# Architect's Supplemental Instructions

Police Department Midtown District

ASI Number 004

1/25/2018

**C400**

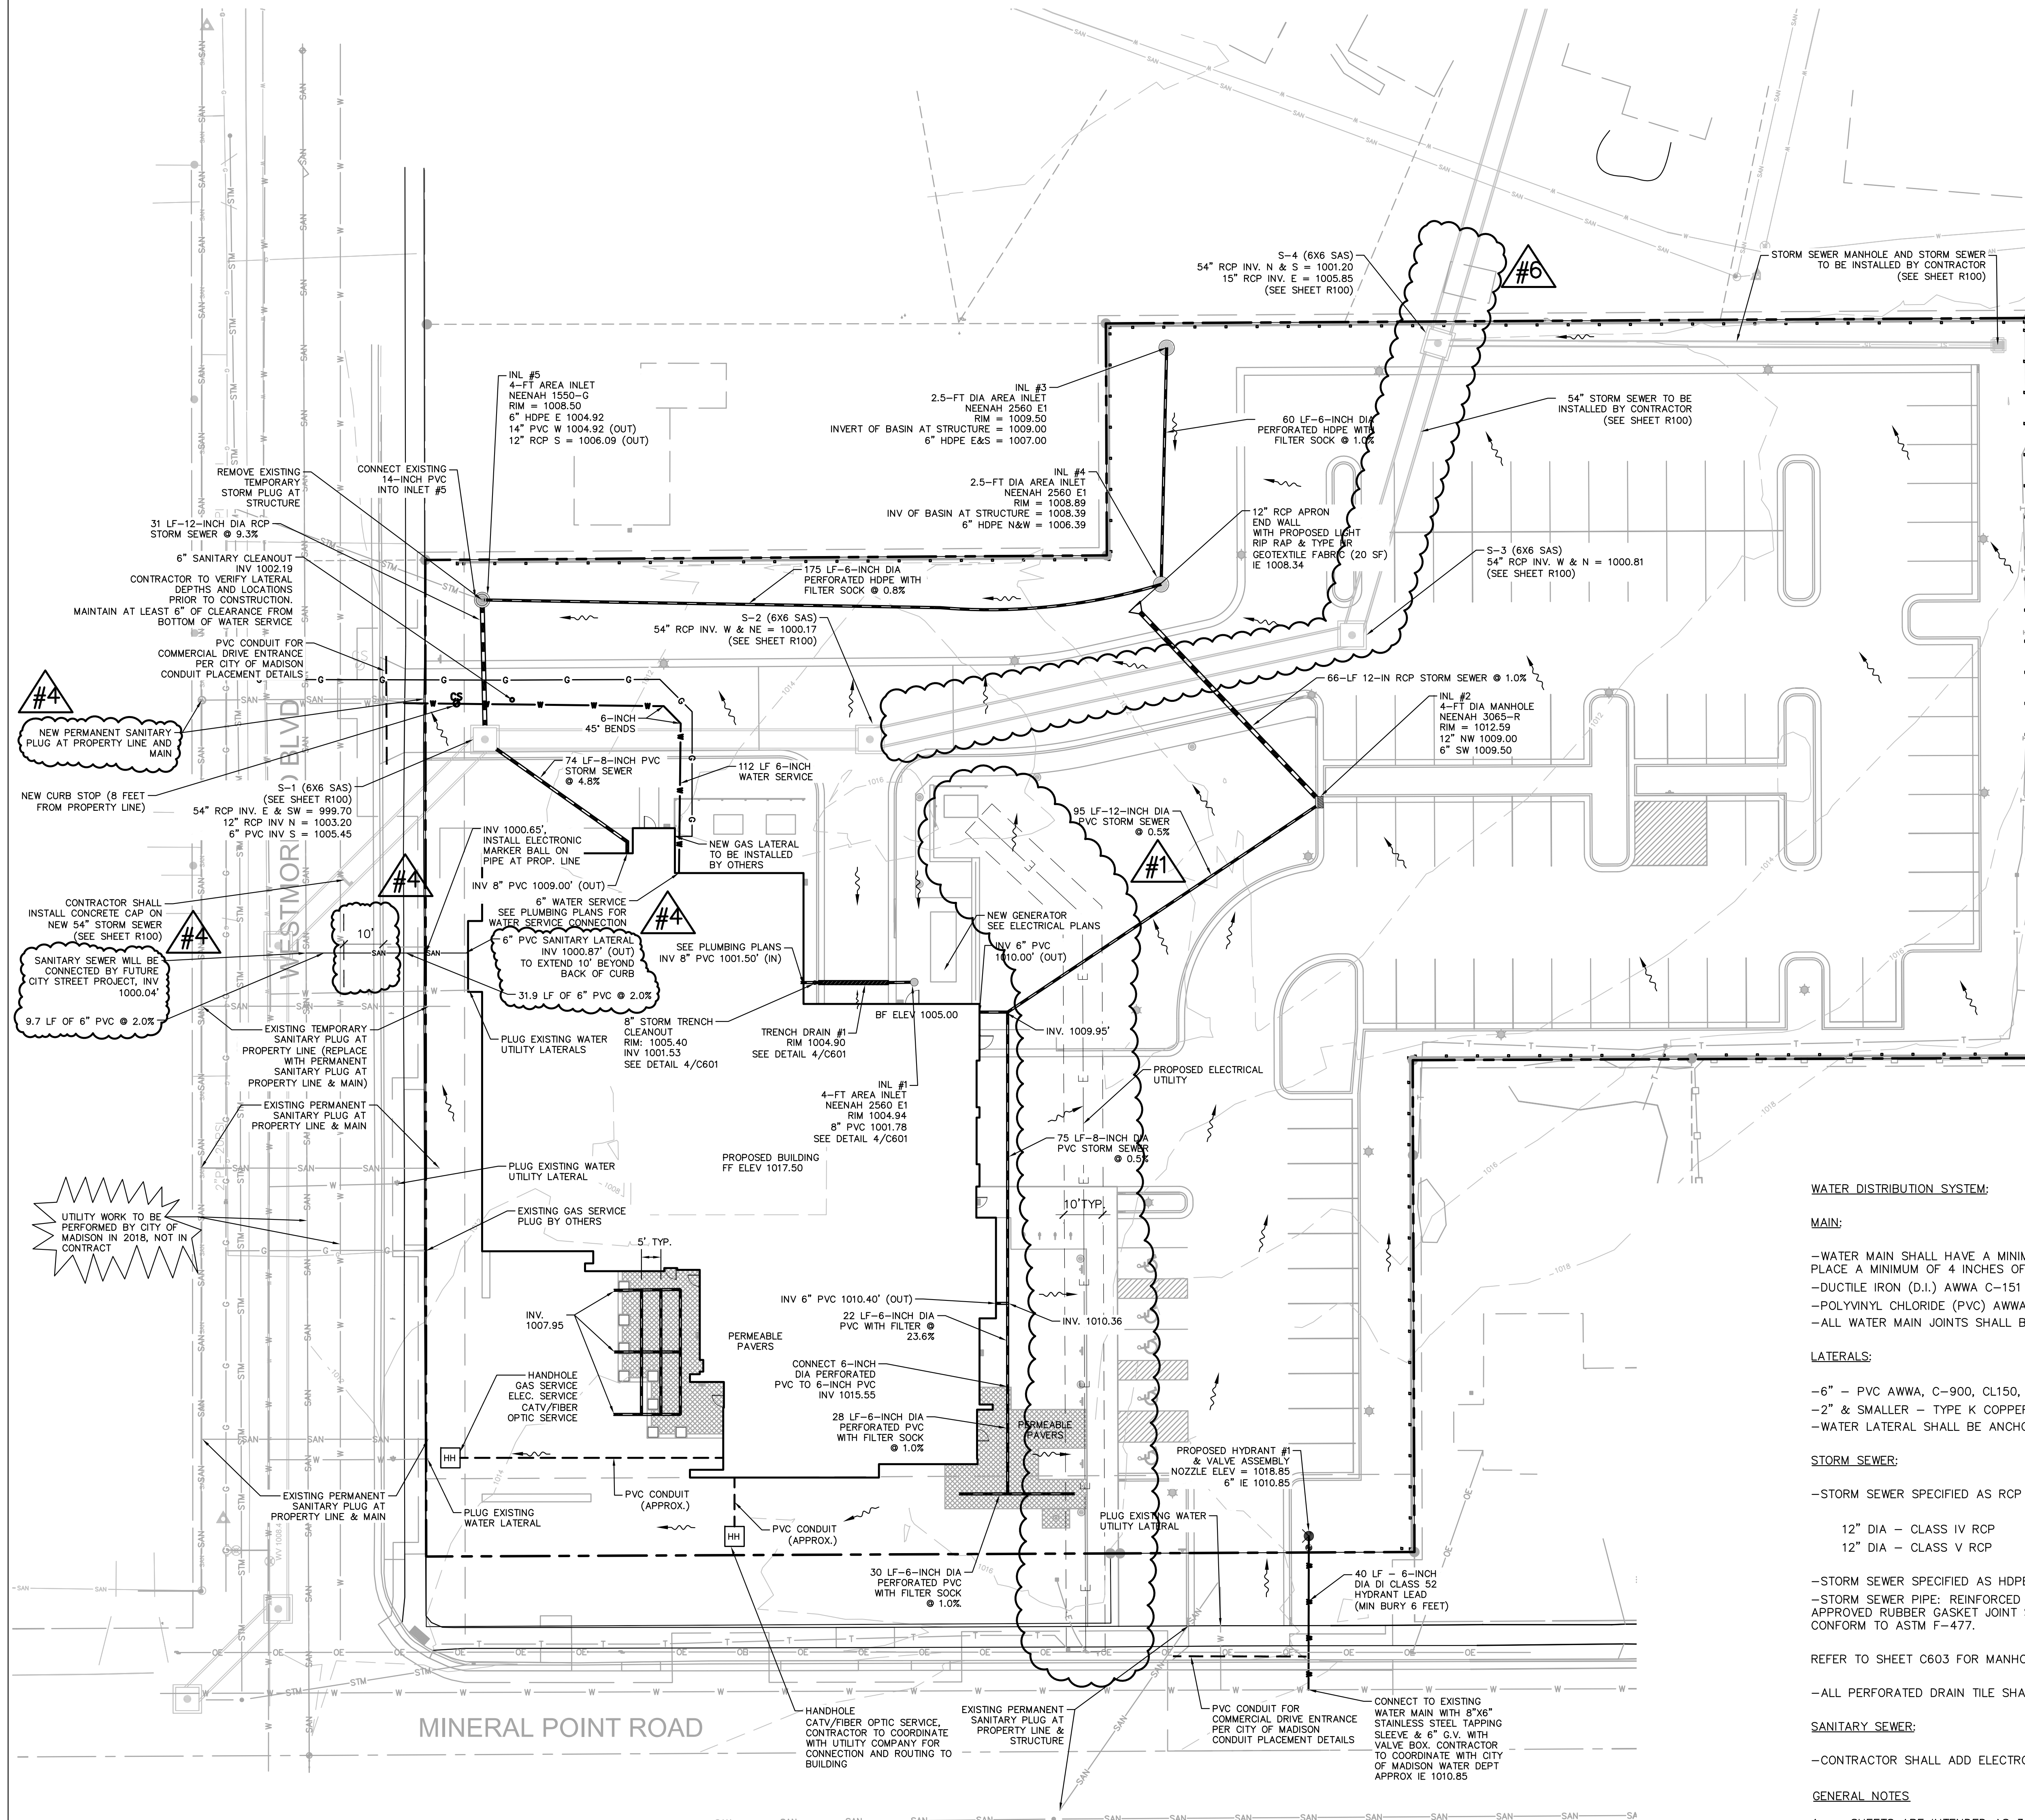
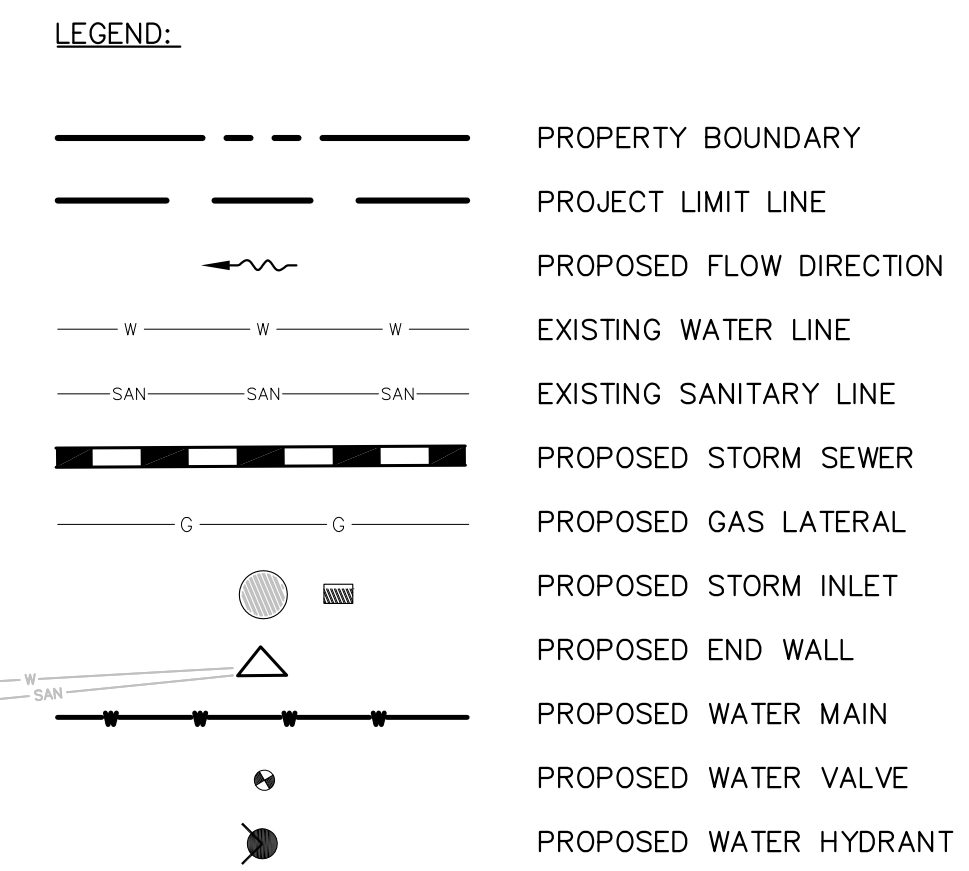
8. The attached sheet C400 has been reissued with the following revisions:
  - A. The 54" storm sewer has been moved to the West. Refer to reissued sheet R100 for additional information.
